UNITED STATES PATENT AND TRADEMARK OFFICE

APPLICATION NO.	FILING DATE	FIRST NAMED INVENTOR	ATTORNEY DOCKET NO.	CONFIRMATION NO.
10/584,968	06/30/2006	Aaron Kaplan	ANVIL.001BNP1	9697

Office Action Summary	Application No. 10/584,968	Applicant(s) KAPLAN ET AL.	
	Examiner DIANNE DORNBUSCH	Art Unit 3773

DETAILED ACTION

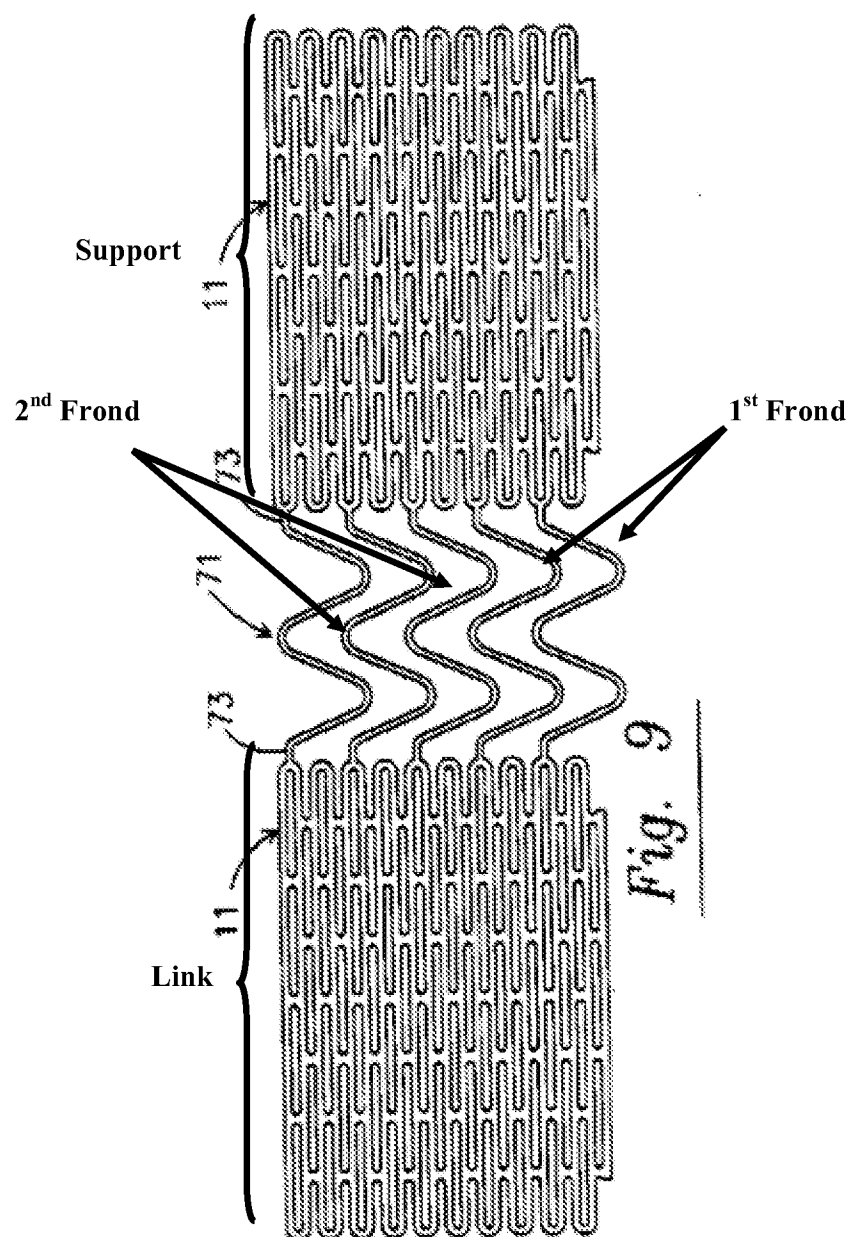
Jayaraman discloses a prosthesis (70) for placement at an opening from a main body lumen to a branch body lumen, the prosthesis comprising: a radially expansible support (see figure below), the support configured to be deployed in at least a portion of the branch body lumen, the support adapted to provide a first radial force to support the

body lumen (once deployed in the vessel it exerts a radial force against the vessel wall); at least two elongate, flexible fronds (see figure below) each having a first end, a second end and an axially extending undulating elongate portions having a plurality of crests and troughs between the first and second ends (see figure below), at least a portion of the elongate portion comprising a plurality of spaced apart filaments (71) having crests and troughs extending in phase (see figure below), the fronds extending from an end of the support and configured to be positioned across the Os and into the main body lumen (see figure below); and at least one circumferential link (see figure below) comprising an undulating pattern including a plurality of crests and troughs (see figure below), the circumferential link being connected at crests thereof to the second ends of the fronds (see figure below), the circumferential link spaced axially apart from the support by the fronds (see figure below); and a plurality of elongate side wall openings in between adjacent fronds (the gaps between each frond seen in the figure below) sized and configured to receive a stent deployment device therethrough; and the elongate, flexible fronds, the support and the circumferential link defining a unitary body as deployed (Fig. 9 and 28), the elongate side wall openings in between adjacent fronds (the gaps between each frond seen in the figure below) for facilitating crossing of a main vessel stent therethrough when the support is positioned in the branch body lumen and the circumferential link is positioned in the main body lumen.

Claim 15: The circumferential link comprises an undulating pattern having at least three apexes (the link contains an undulating pattern with more than three apexes as seen in the figure above).

Claim 36: At least one frond comprises a plurality of parallel, undulating filaments (see figure above).

Claim 43: That the circumferential link comprises a single transverse filament (see figure above where the link is made from a single material that is laser cut (Col. 4 Lines 10-20).

Claim 44: Comprising a transition section (73) between the support and the fronds (see figure above).
